CITY OF VINELAND

**RE: Street Lighting Recommendations  
September 2017**

## STREET LIGHTING RECOMMENDATIONS

SEPTEMBER 2017

SHEET 5 OF 5

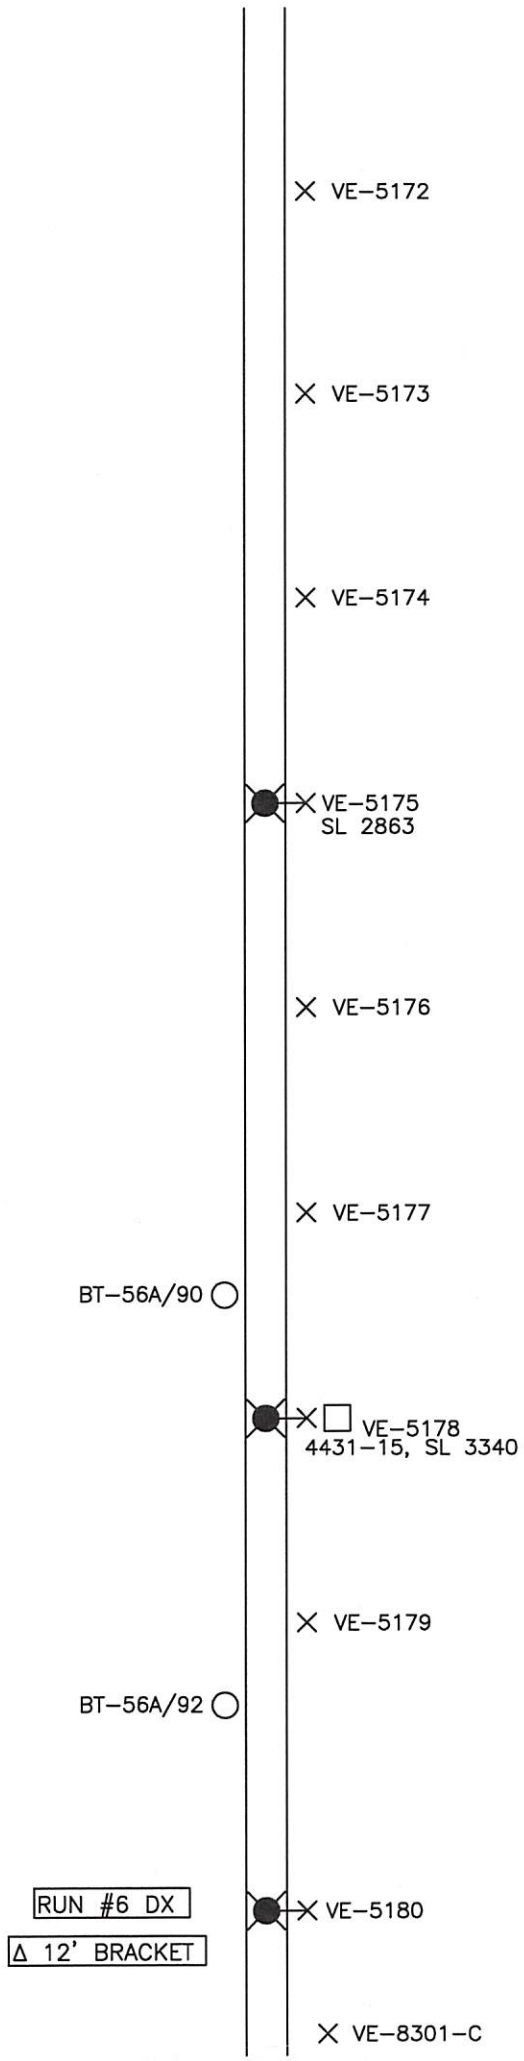
4. Area of West Boulevard  
*(between Chestnut Ave & Grant Ave)*  
Drawing No. VMEU-2842  
Upgrade four (4) existing street lights to 74W LED, twenty-two (22) to 108W LED (relocating two), and one (1) to 160W LED. Install an additional one (1) 74W LED, and eight (8) 108W LED street lights onto existing utility poles.

**PROPOSED:** Upgrade four (4) existing street lights to 74W LED, twenty-two (22) to 108W LED (relocating two), and one (1) to 160W LED. Install an additional one (1) 74W LED, and eight (8) 108W LED st. lts. onto existing utility poles.

<p><b>PROPOSED STREET LIGHT REVISION</b>          AREA OF GRANT AVE BETWEEN EAST BLVD AND LINCOLN AVE</p>	
<p><b>VINELAND MUNICIPAL ELECTRIC UTILITY</b>  <b>VINELAND, NEW JERSEY</b></p>	
DRAWN: CAM	VAULT # F-3-C
DATE: 8/11/2017	DRAWING # VMEU-2843
SCALE: NTS	CHECKED:

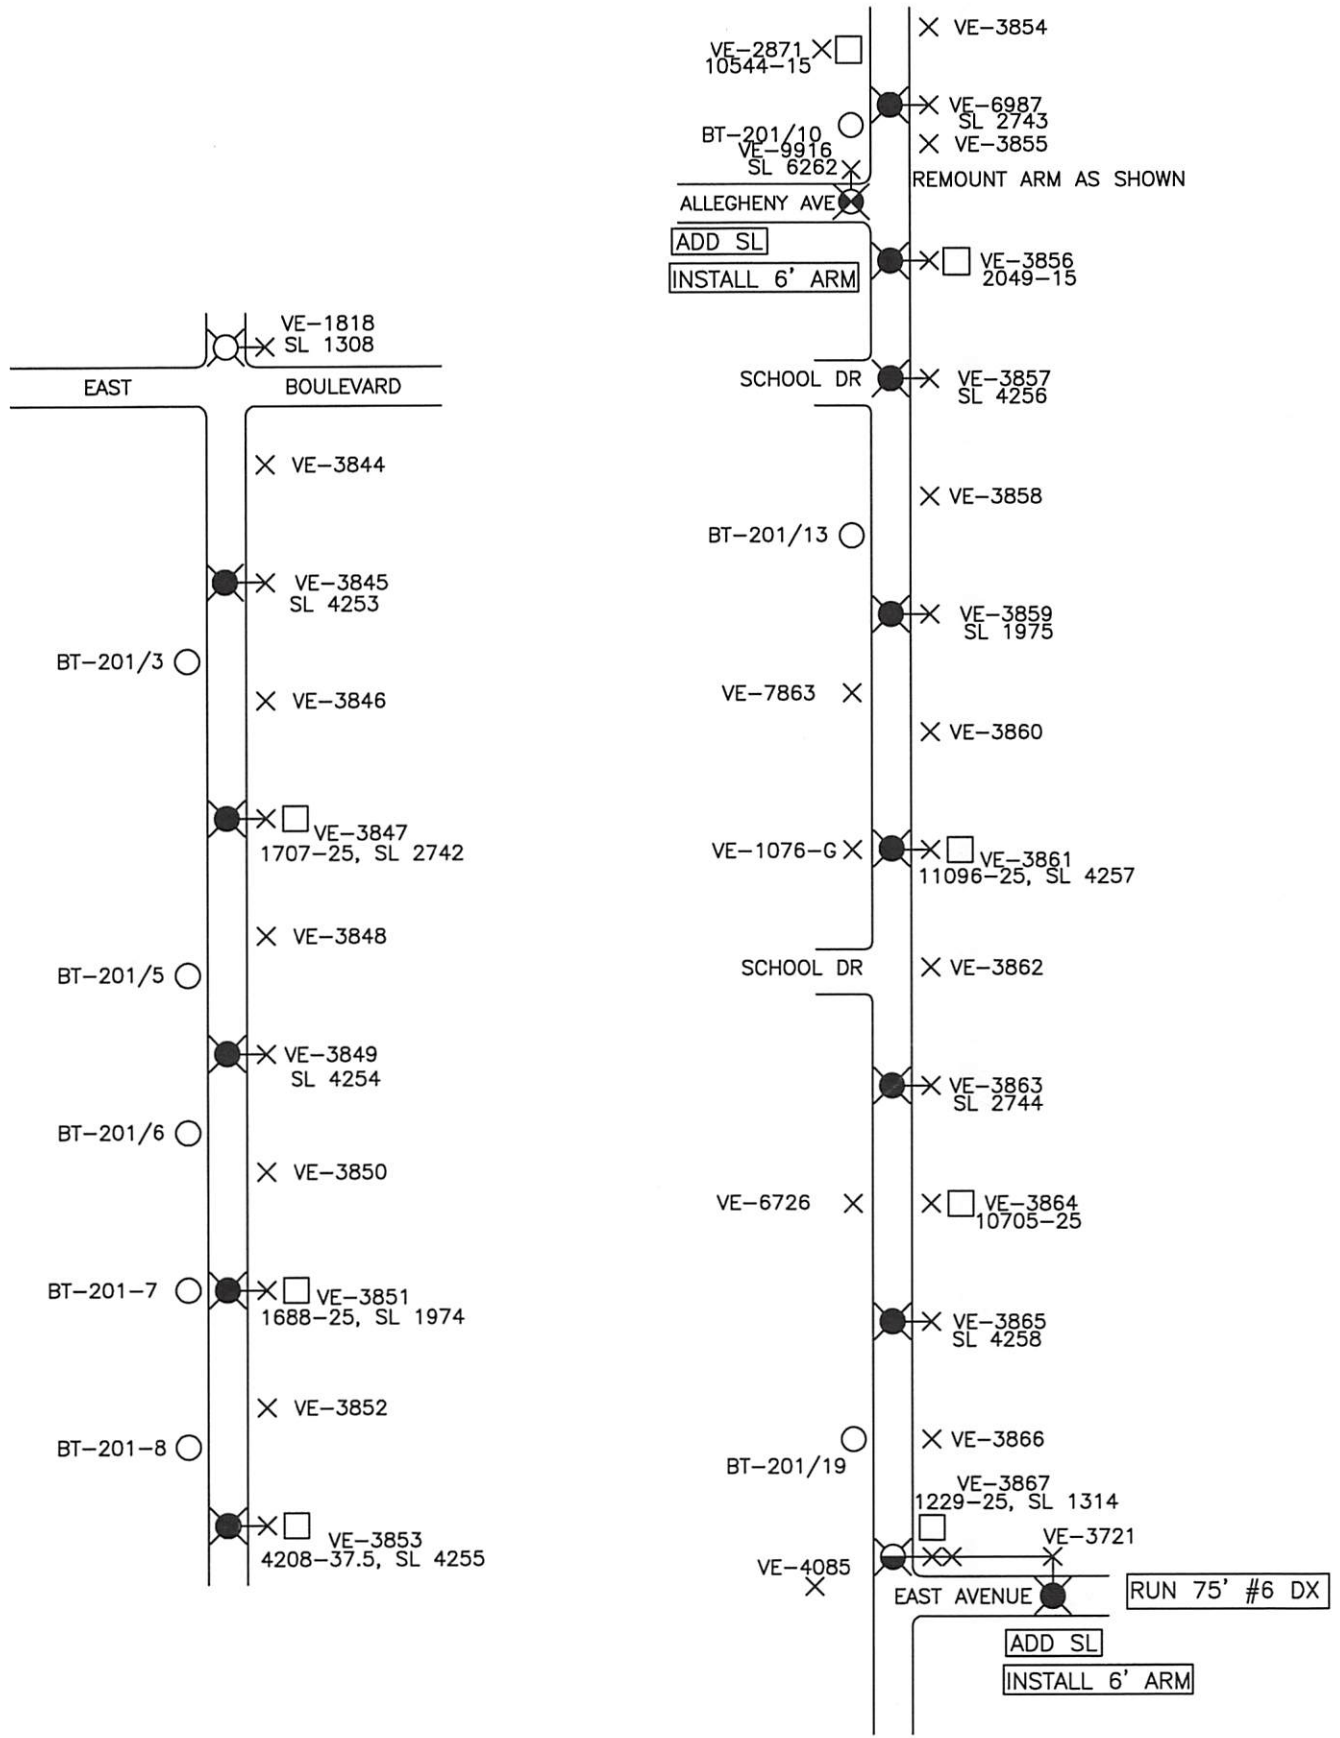
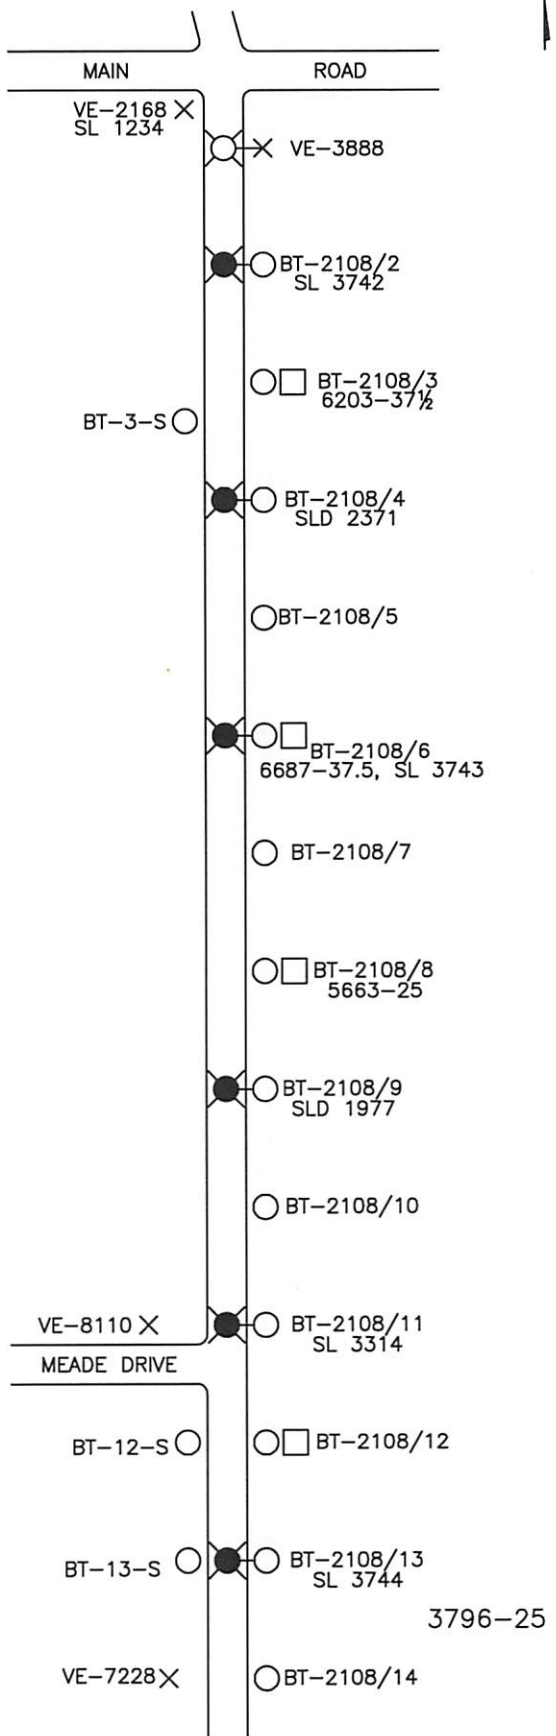
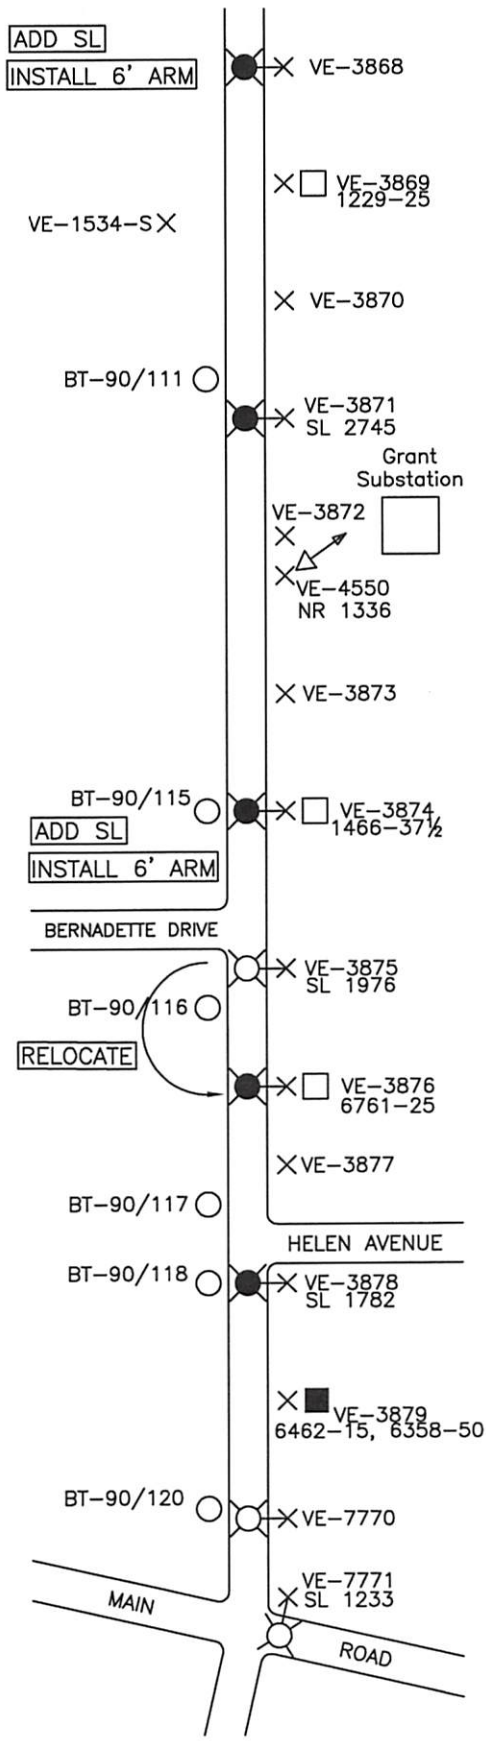
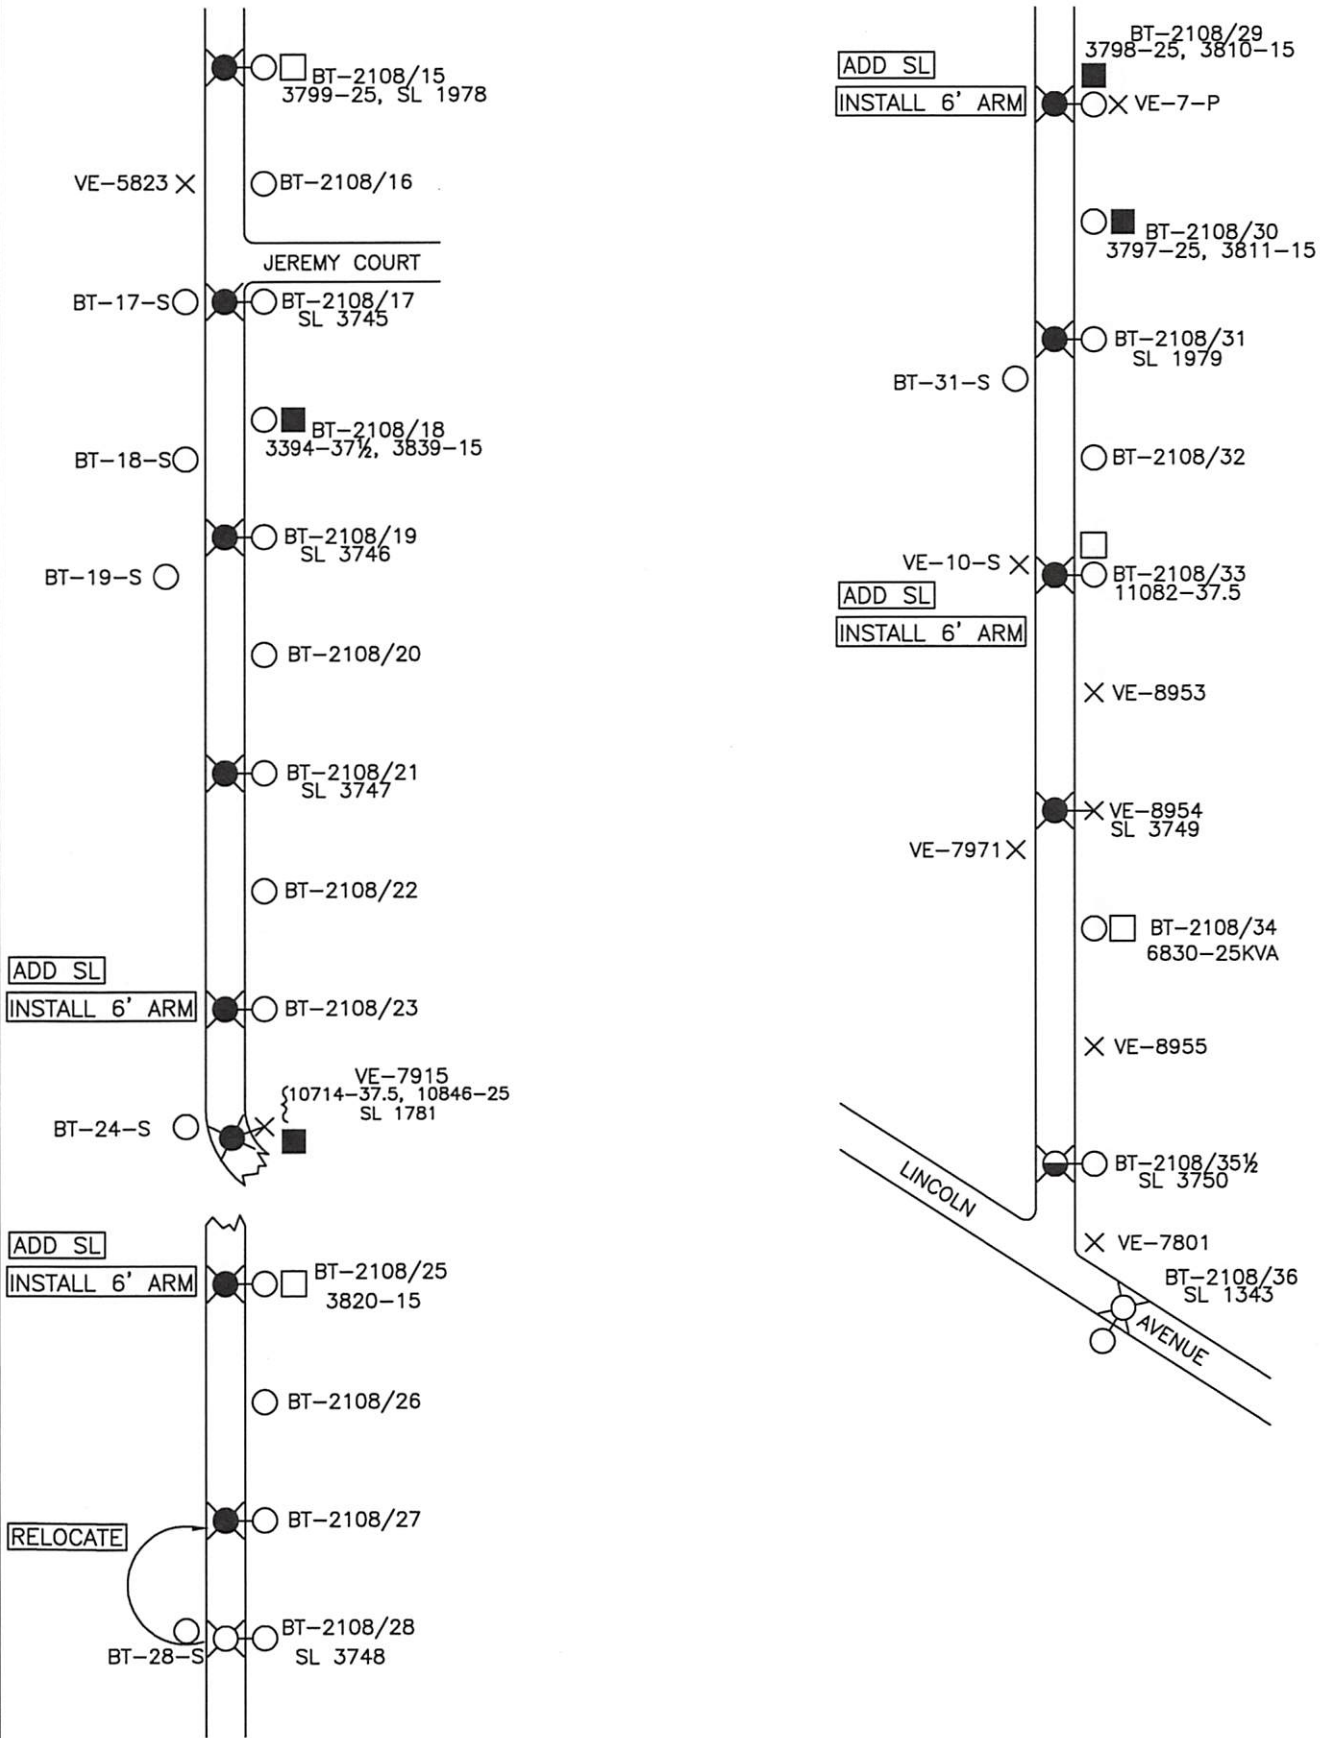
5. Area of Grant Avenue  
*(between East Blvd & Lincoln Ave)*  
Drawing No. VMEU-2843  
Upgrade one (1) existing street light to 54W LED, twenty-eight (28) to 74W LED (relocating two), and two (2) to 108W LED. Install an additional eight (8) 74W LED street lights onto existing utility poles.

**PROPOSED:** Upgrade one (1) existing street light to 54W LED, twenty-eight (28) to 74W LED (relocating two), and two (2) to 108W LED. Install an additional eight (8) 74W LED st. lts. onto existing utility poles.
